NORTHEAST UTILITIES

June 12, 1984

Millstone Nuclear Power Station, Unit No. 3
Summary/Submittal of Responses to PSB Electrical Draft SER Items

Status of PSB Electrical SER Items

430.10
8

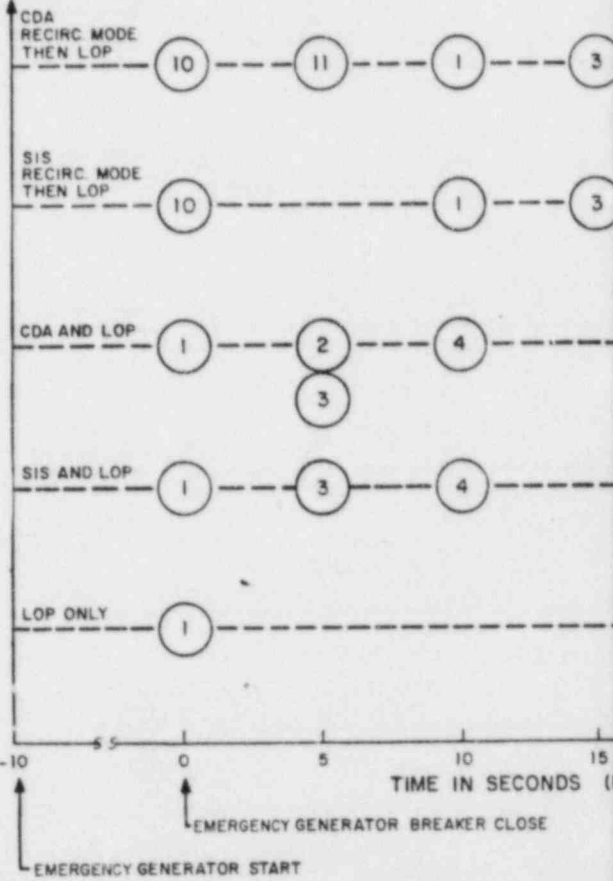
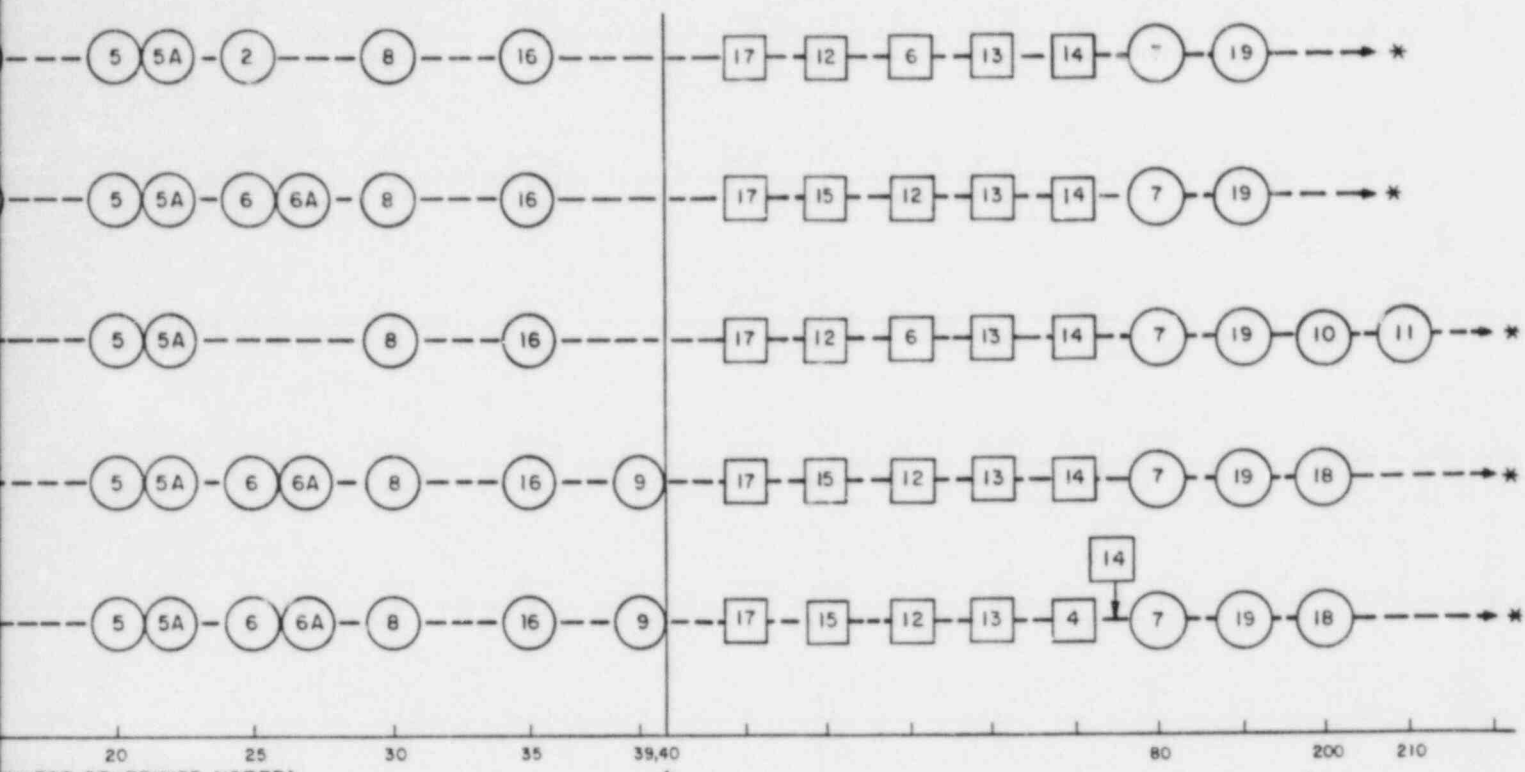
The applicant by amendment 3 revised the FSAR to indicate that automatic reset occurs only when there is a loss of offsite power subsequent to an accident signal. Based on the revision to the FSAR it appears that the load sequencer is used to sequence loads on either onsite and offsite power subsequent to an accident signal. Based on the revision to the FSAR it appears that the load sequencer is used to sequence loads on either onsite and offsite power sources when there is an accident signal. This use of the load sequencer contradicts FSAR section 8.3.1.1.3 which states that the load sequencer is used only to sequence loads onto ~~power source~~. Clarification of this time will be pursued with the applicant and the results of the staff review will be reported in a supplement to this report.

Question No. Q430.10 (SRP Section 8.3.1, Appendix 8A) 1.11

Refer to revised FSAR Section 8.3.1.1.3, Item 1, starting and loading, for clarification of the use of the emergency generator load sequencer relative to the containment recirculation pumps. In addition, refer to FSAR Section 6.2.2.2, containment recirculation system, for the accident analysis relative to the containment recirculation pumps. 1.X0
1.X1
1.22
1.X2
under

Refer to revised FSAR Section 8.3.1.1.3, Item 1, starting and loading, for the conditions under which the EGLS will automatically reset. 1.24
1.25

The capacity of one emergency generator is sufficient to meet 3.56
 the engineered safety features demand caused by the range of 3.57
 incidences shown in Table 8.3-1. The emergency generator 3.58
 loading sequence for the above shutdown condition is also 3.59
 stated in Table 8.3-1. The loading sequence prevents system 3.60
 instability during motor starting. A fast responding 4.2
 exciter and a voltage regulator ensure quick voltage 4.3
 recovery after any load step. Each emergency generator unit 4.4
 has two start control circuits.

Sequential loading is achieved by an emergency generator 4.6
 load sequencer (EGLS). The EGLS automatically performs the 4.8
 functions of load shedding, load blocking, and sequential
 load application under the conditions of LOP, SIS and LOP, 4.9
 and CDA and LOP. Under the conditions of SIS without LOP 4.10
 the EGLS does not introduce load shedding, load blocking, or 4.11
 sequential load application into any of the control circuits 4.12
 of the engineered safety features. Under the condition of 4.13
 CDA without LOP, the EGLS delays the start of the
 containment recirculation pumps but does not introduce load 4.14
 shedding, load blocking, or sequential load application
 into the control circuits of any other engineered safety 4.15
 feature. All EGLS interactions with the control circuits of 4.16
 the engineered safety features are within the time intervals
 allowed by the accident analysis. 4.17

During the first 40 seconds, the EGLS sequences initial 4.19
 damage mitigating loads automatically. After the first 4.20
 40 seconds, the manual start block signal is removed and
 additional emergency bus loads may be started manually. 4.21
 Typical loads manually started are the pressurizer heaters, 4.22
 the fuel pool cooling pump, and turbine protection
 equipment. 4.23

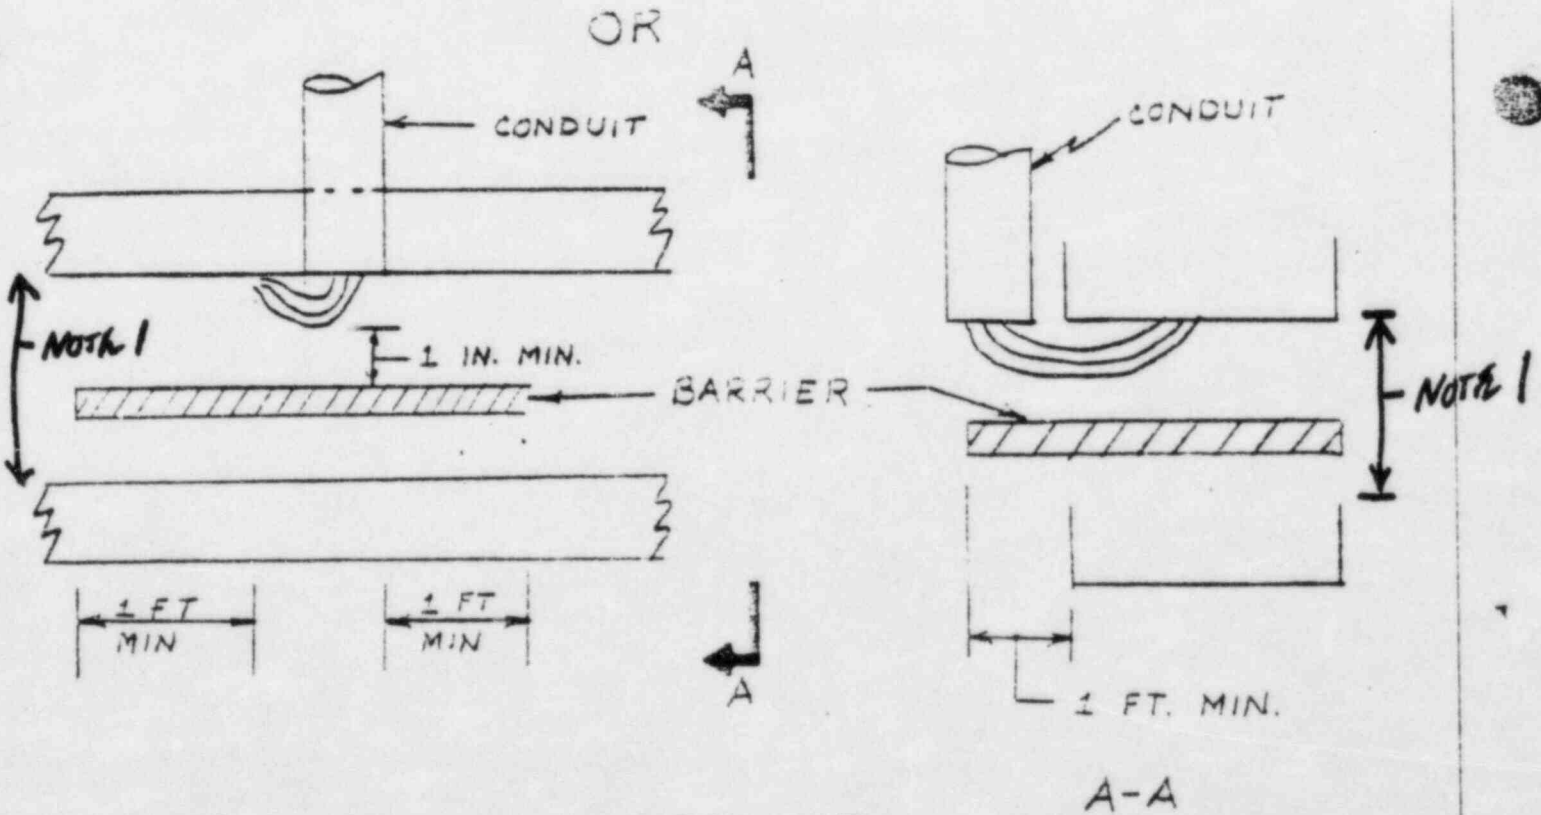
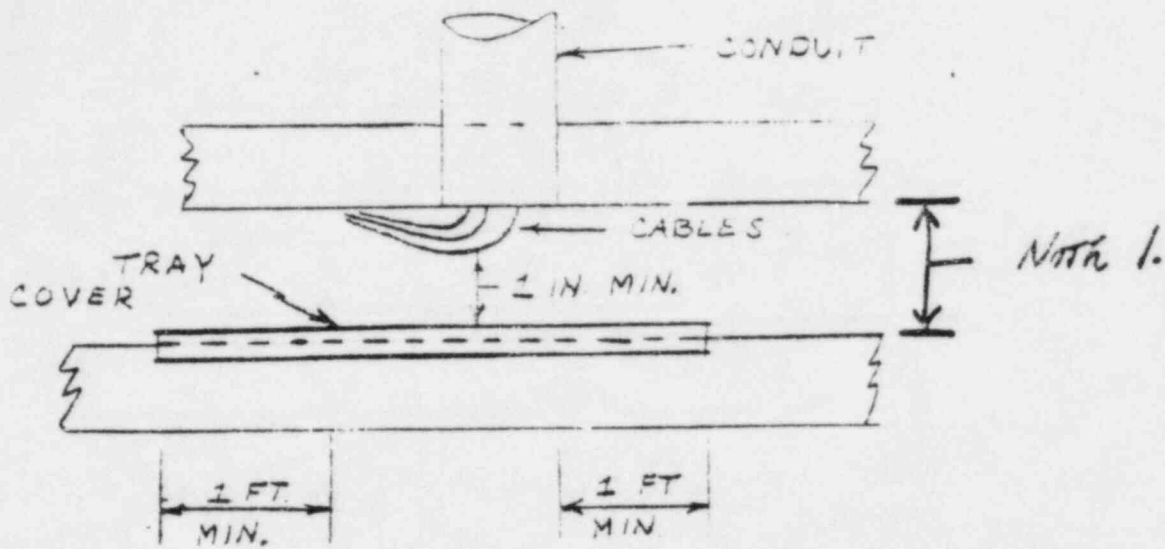
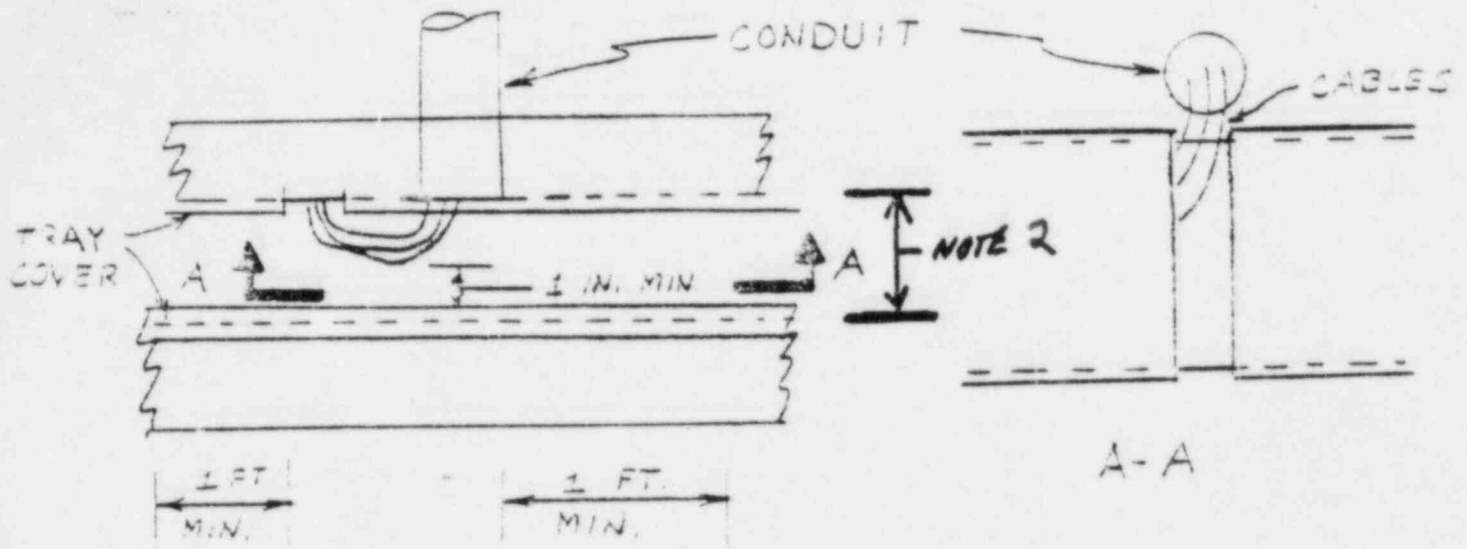
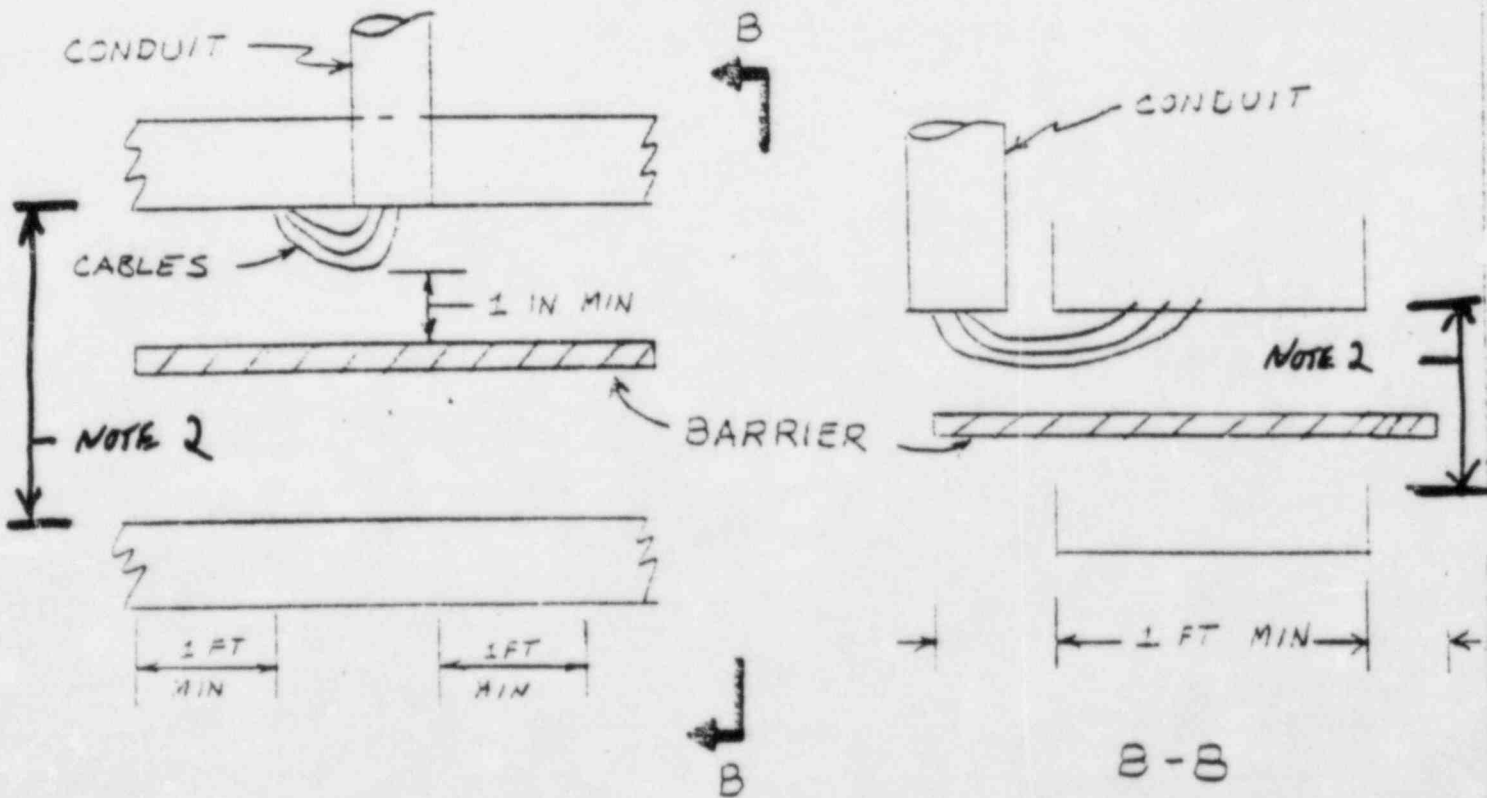
Question No. Q430.36 (SRP Sections 8.3.1 and 8.3.2) 1.12

Refer to revised section 1.8, R. G. 1.75 and new Figure 8.3-8.

1. <u>General (Clarification)</u>	1.18 1.19 1.21
		For separation purposes, location of cable entry/exit from cable tray is considered to be equivalent to perpendicular cable tray crossings. Refer to Figure 8.3.8.	1.23 1.24 1.25 1.26
		Ventilated tray covers are considered equivalent to solid tray covers.	1.28 1.29
